NRC Staff Comments on FAQ 08-0054, Revision 0 [HTB, SCD] {December 2010}
FAQ Number 08-0054 FAQ Revision 0
FAQ Title Demonstrating Compliance with Chapter 4 of NFPA 805

Plant: Oconee Nuclear Station Date: August 19, 2010
Contact: David Goforth Phone: 704-249-5607
Email: David.goforth@duke-energy.com

Figure 4-3 - Fire Area by Fire Area Transition Process (Simplified)

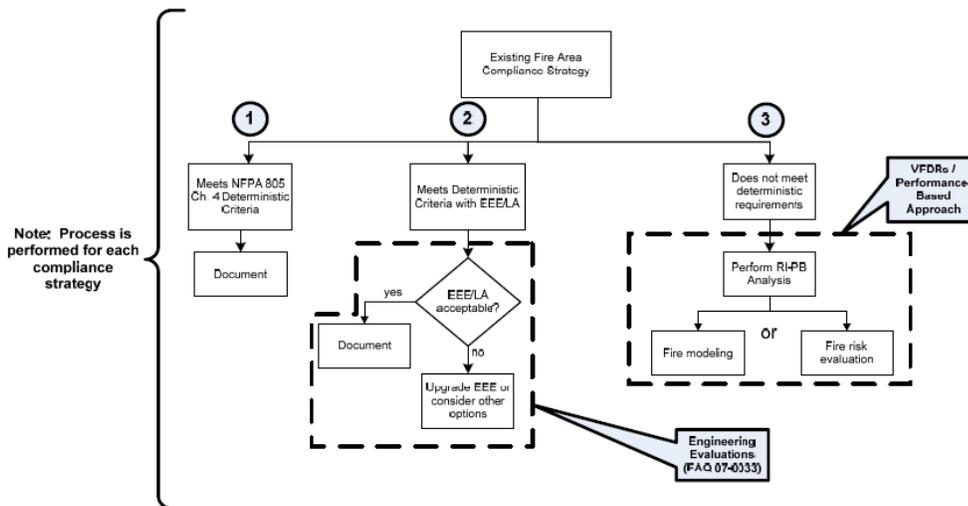
Comment [H2]: Under column 2, the dotted outline should also include staff approved licensing actions (Appendix R exemptions/NUREG 0800 Deviations). Right now, the added information box only mentions Existing Evaluations (FAQ 07-0033).

Figure B-TBD2 – FRE Process (NFPA 805 Transition)

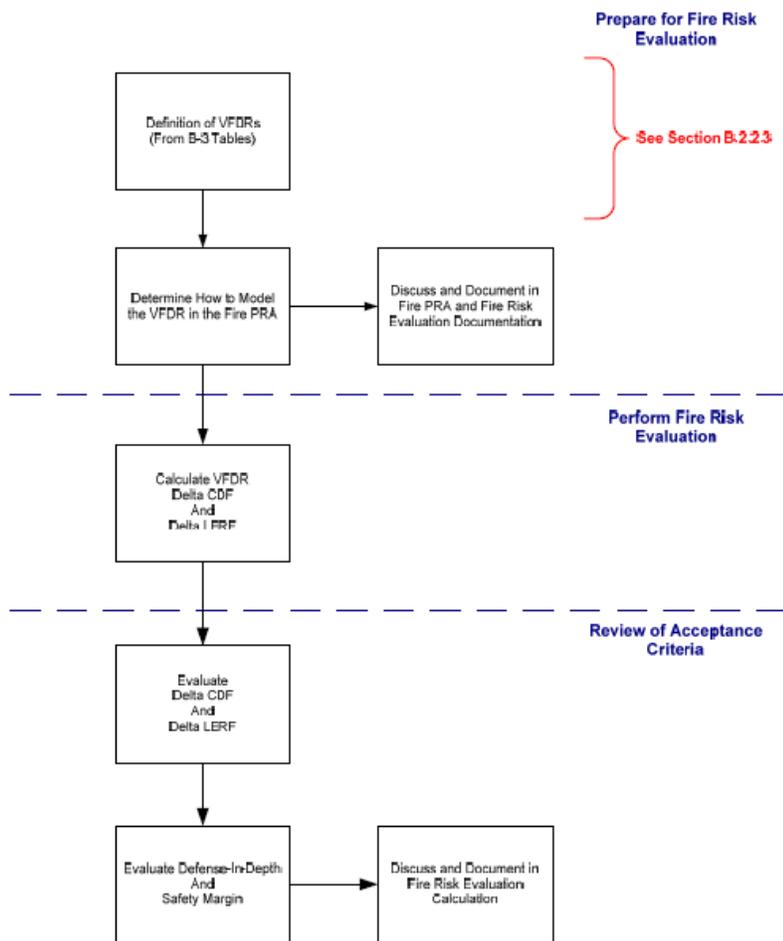
Comment [H7]: Top box - Using the word "Identification" rather than "Definition" sounds better and is more accurate.
